8-E-22-HZ
APPLICATION FOR CERTIFICATE OF APPROPRIATENESS

1315 Forest Ave. 37916
Ft. Sanders NC

Staff Report

File Number: 8-E-22-HZ

① SITE PLAN
1/16" = 1'-0"

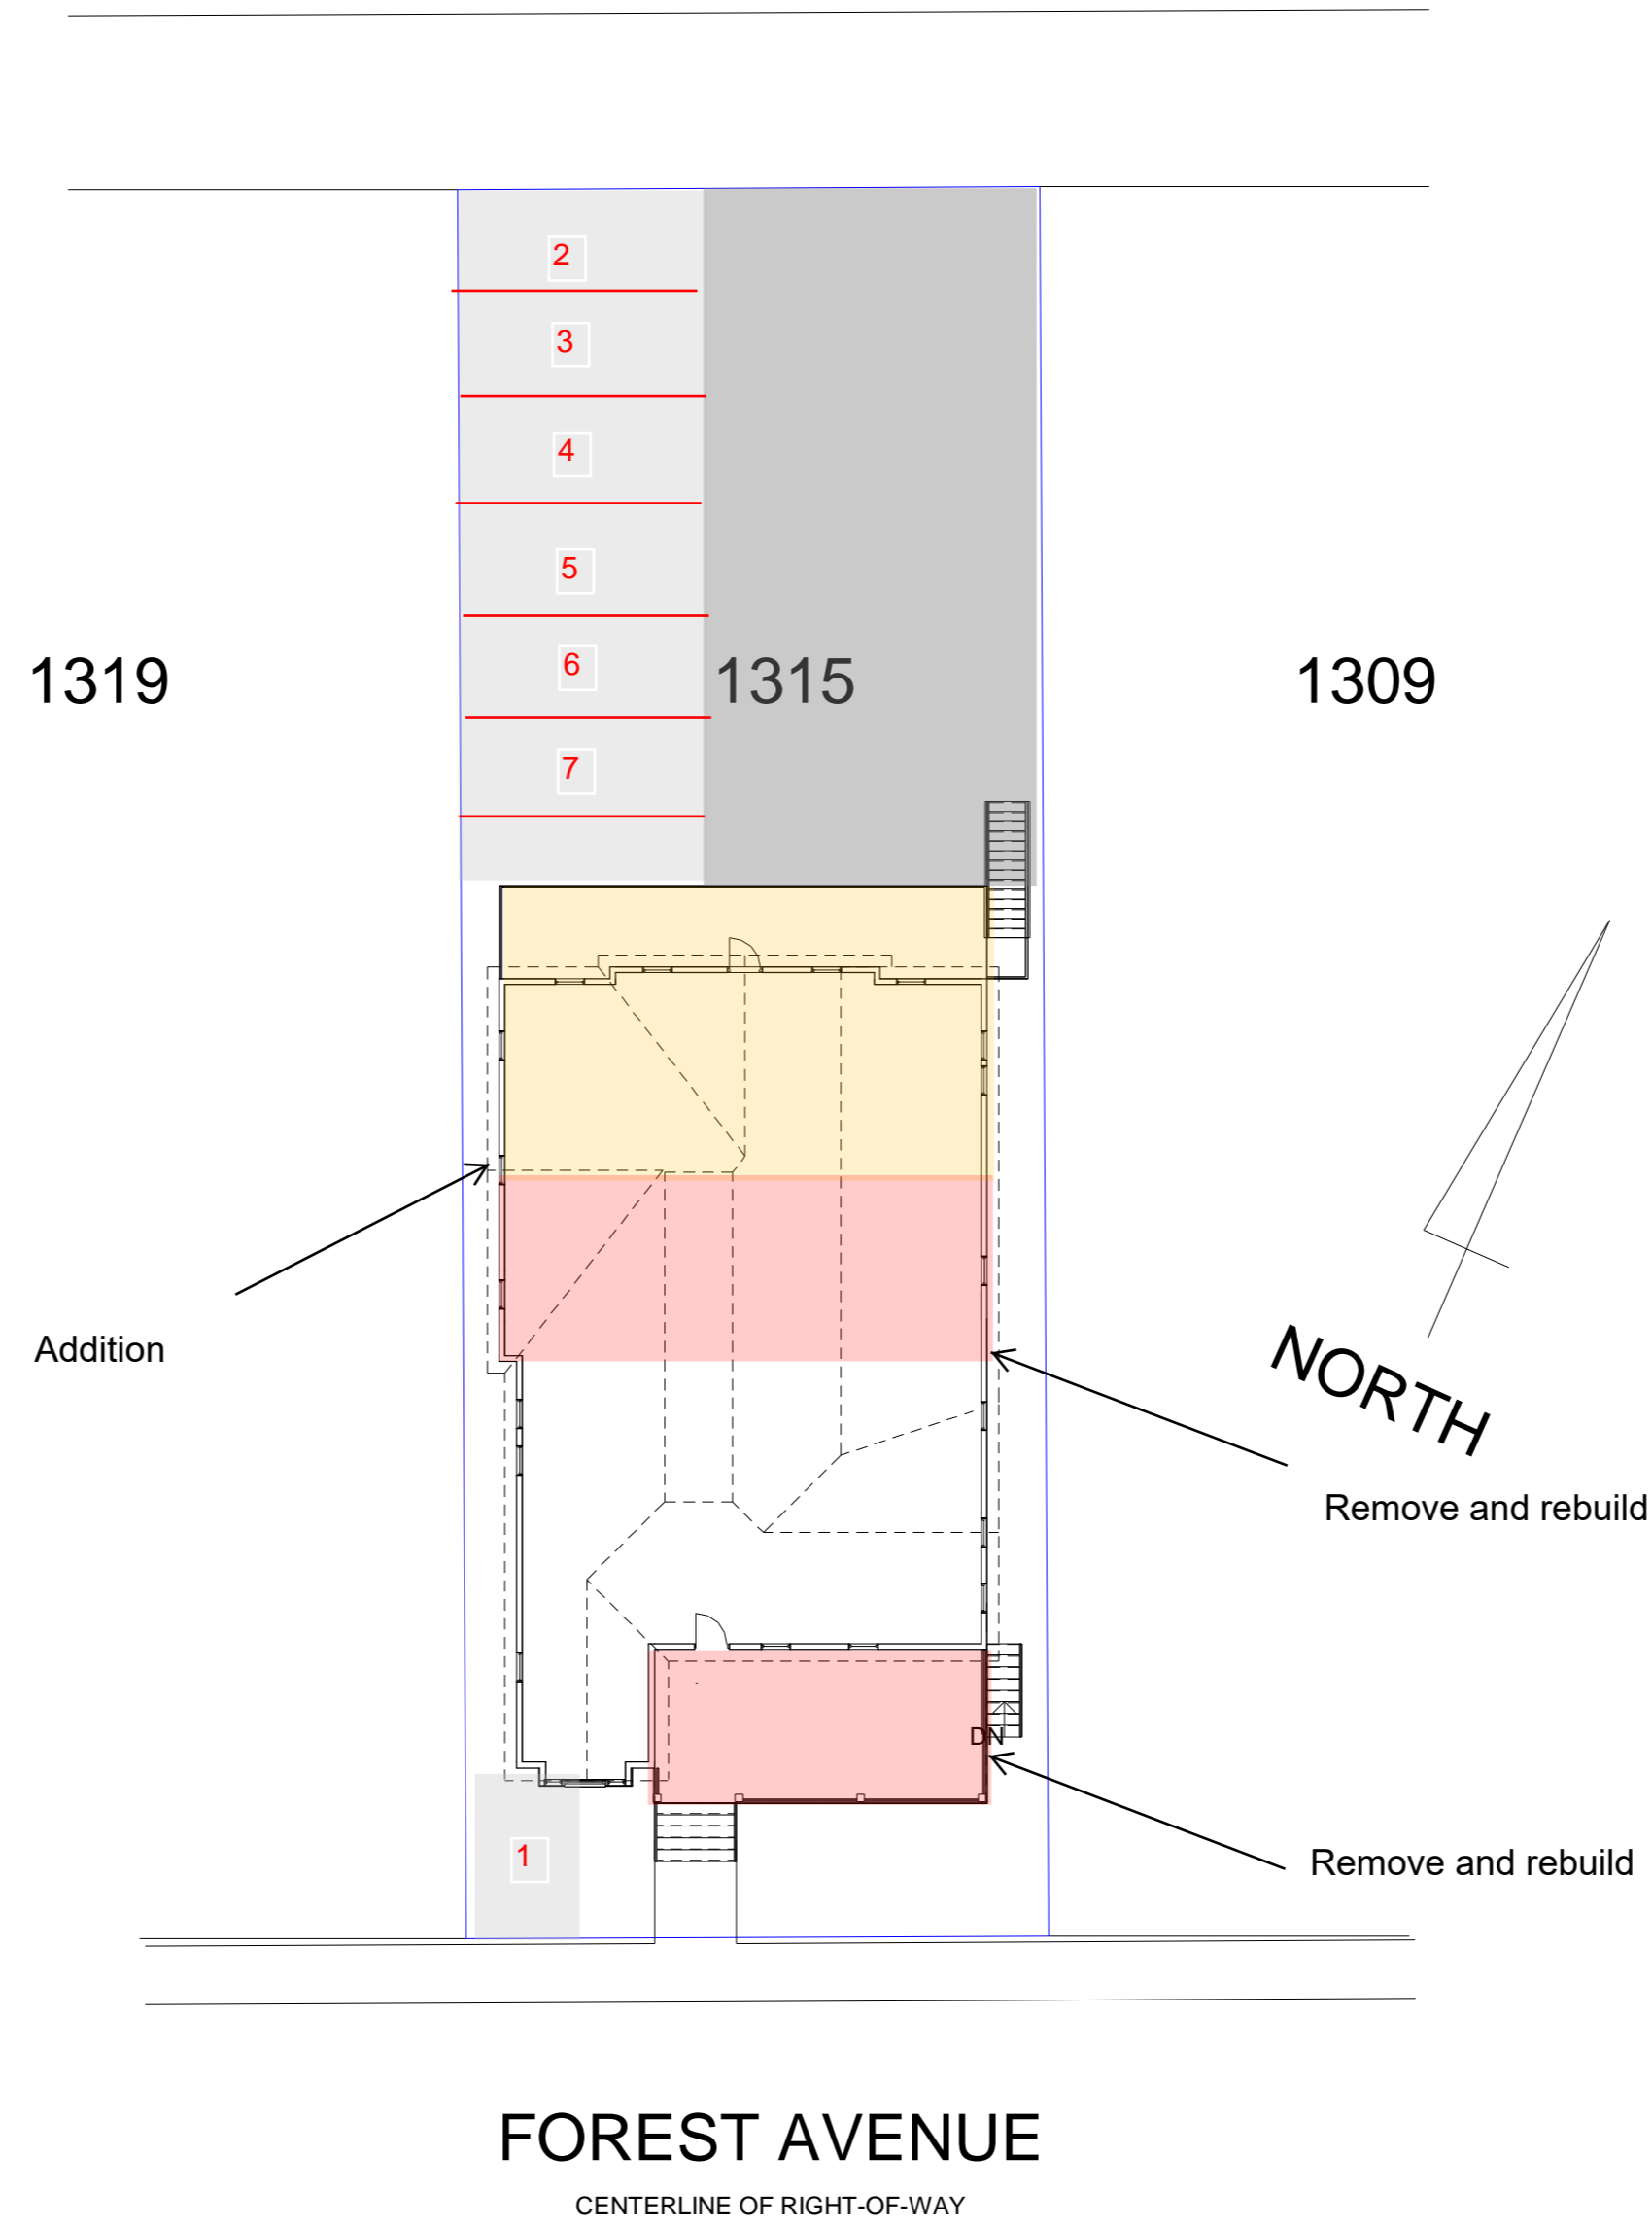
9. Final modifications to the site plan will be necessary to meet City Engineering standards for parking. Per the Fort Sanders design guidelines, front yard parking is discouraged. The house and parking area need to remain below 45% impervious surface for the RN-5 zoning. The final site plan could be approved by staff, provided there are no substantial modifications to the addition's design and placement.

④ FRONT ELEVATION
1/8" = 1'-0"

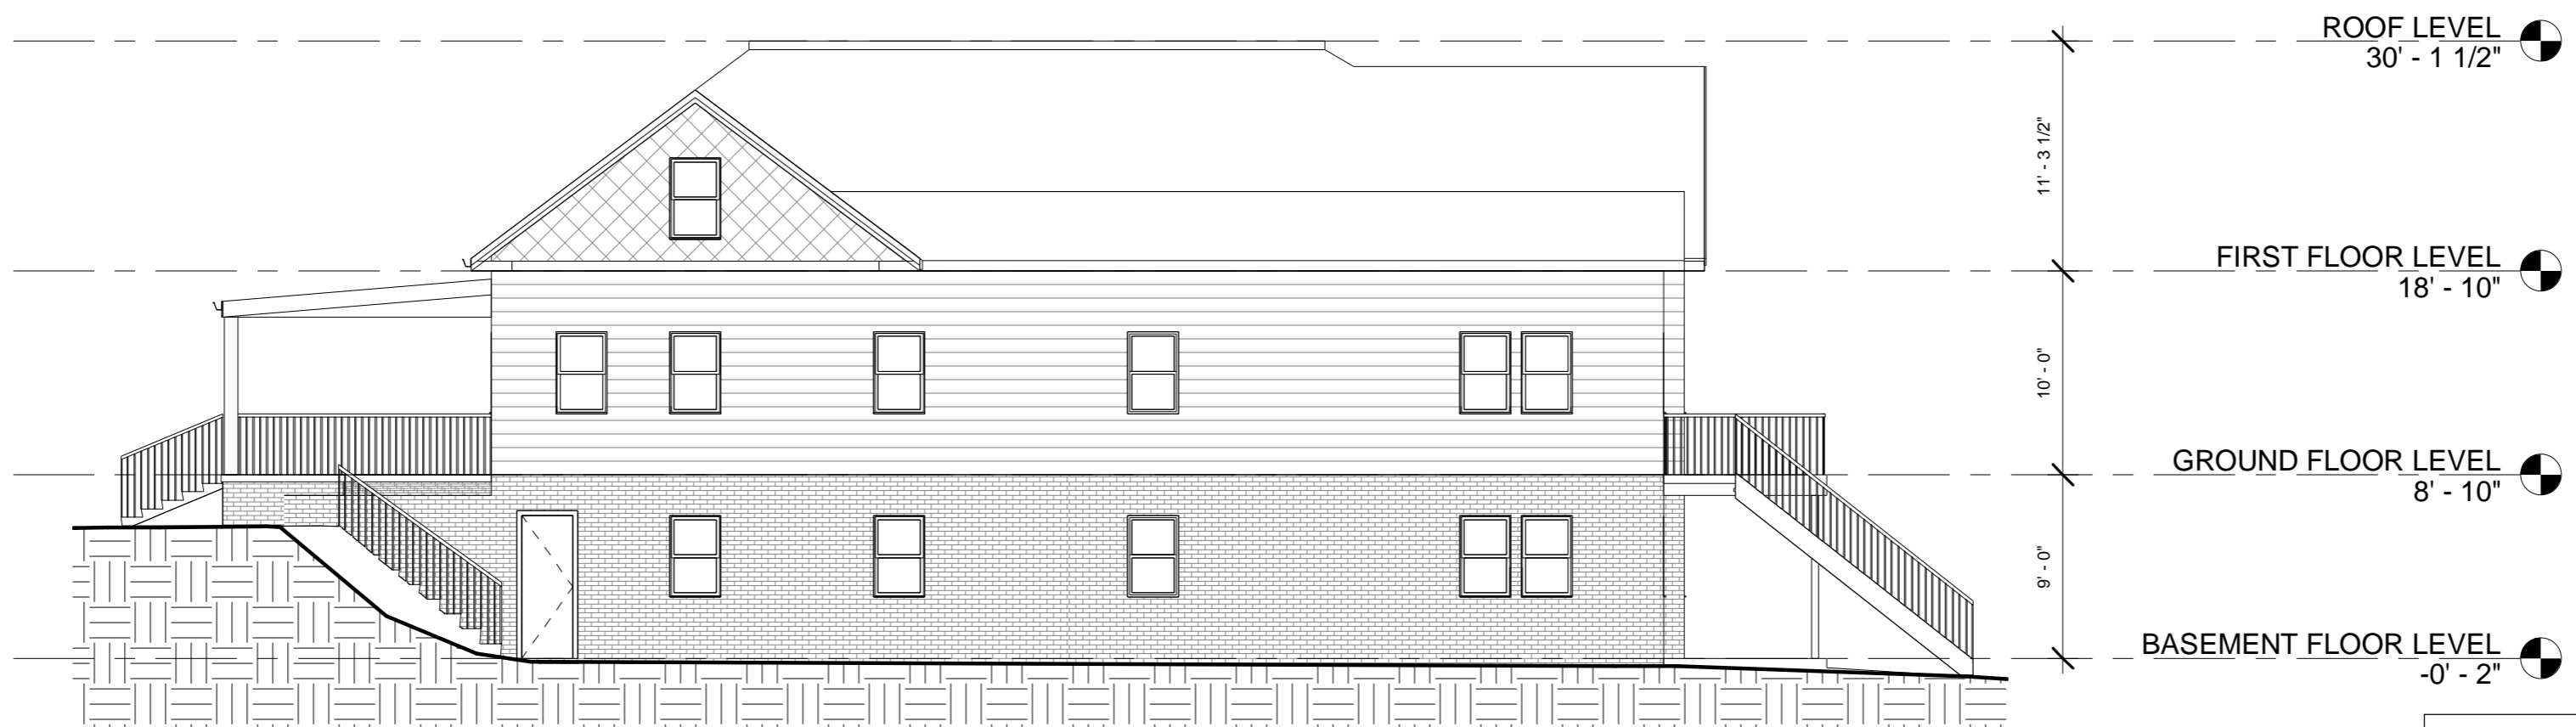
5. Removal of the non-historic enclosed front porch and side addition meets the design guidelines. Reconstruction of a front porch meets the design guidelines, which recommend to "provide porches with proportions and materials which complement pre-1940 houses." The applicant has revised the flat-roof front porch to incorporate a small shed-roof slope. The new porch columns should receive additional detail (turned wood posts, larger square columns, chamfered details, etc).

② SIDE ELEVATION 2
1/8" = 1'-0"

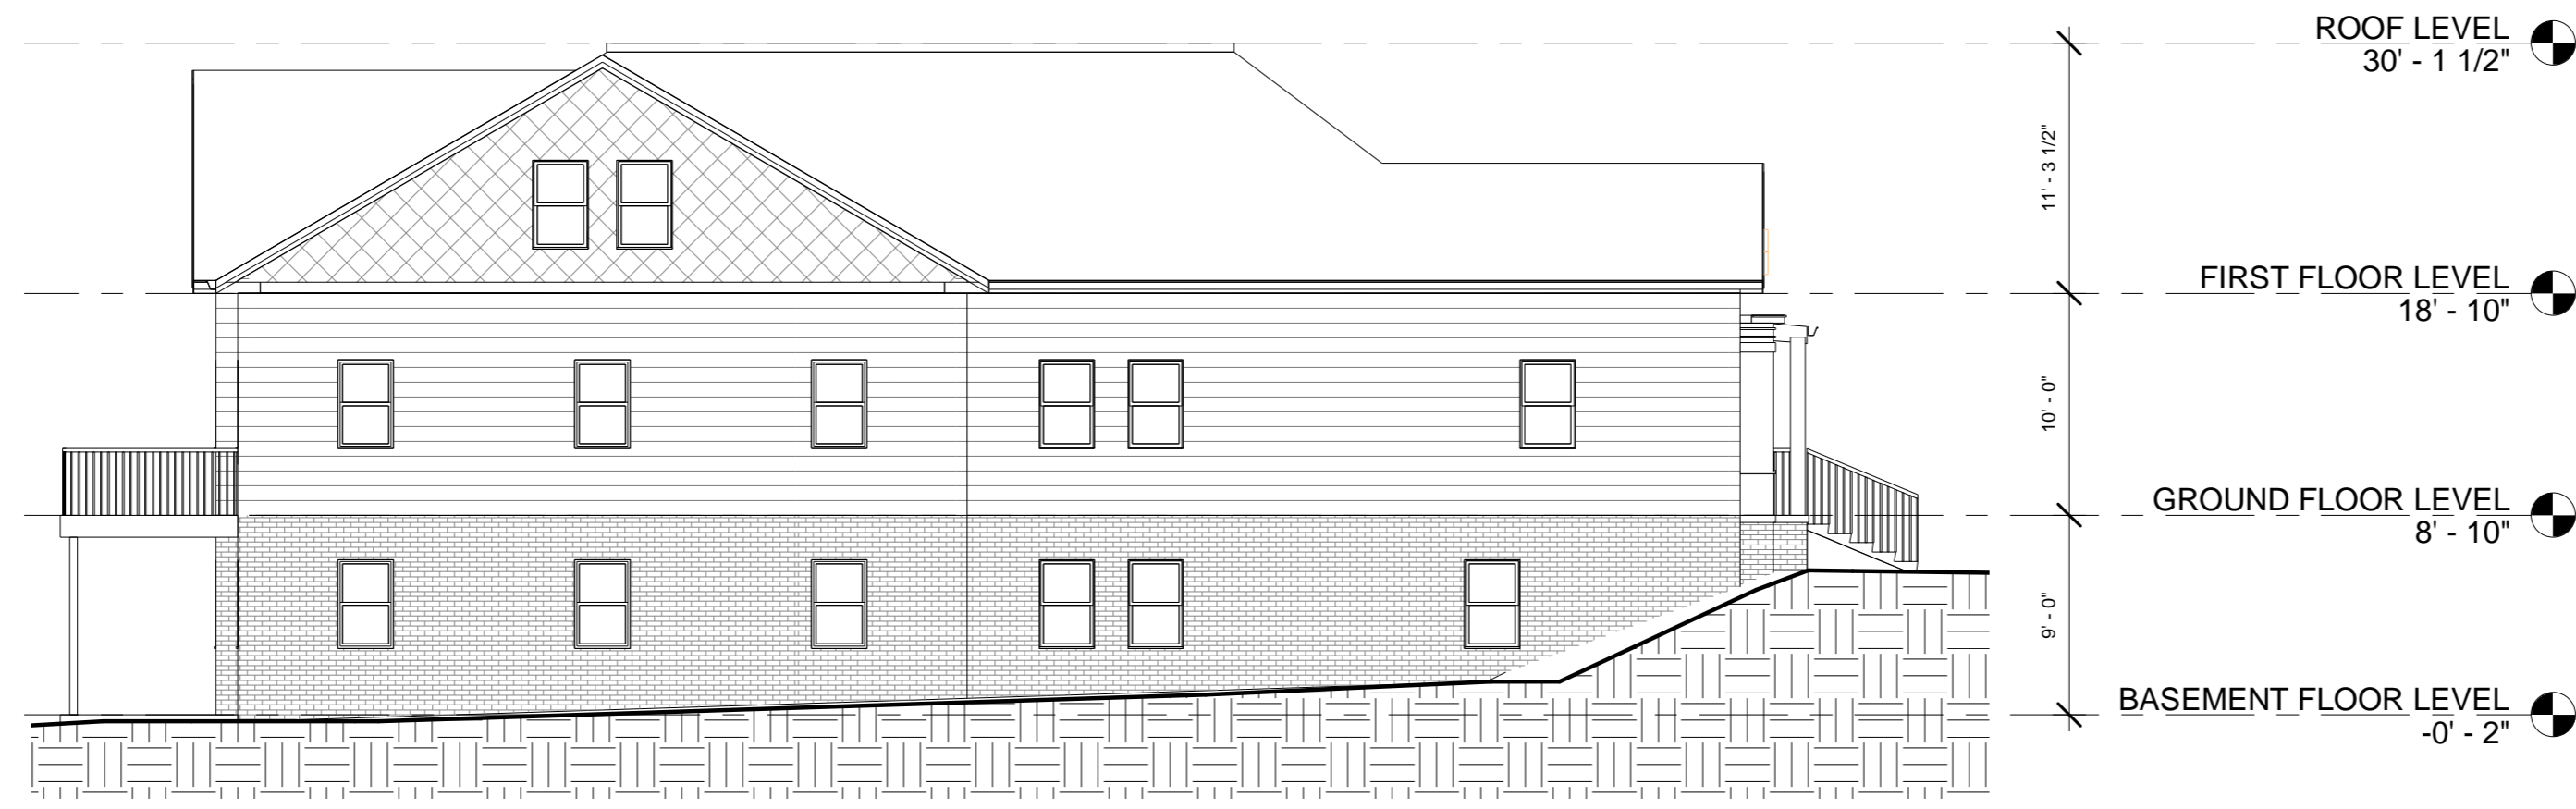
4. The west elevation (side elevation 2) has been revised to incorporate two windows instead of one on the third-story gable field. The applicant should clarify the design, materials, and operation of the new bay window on the façade, including the bulkhead area.
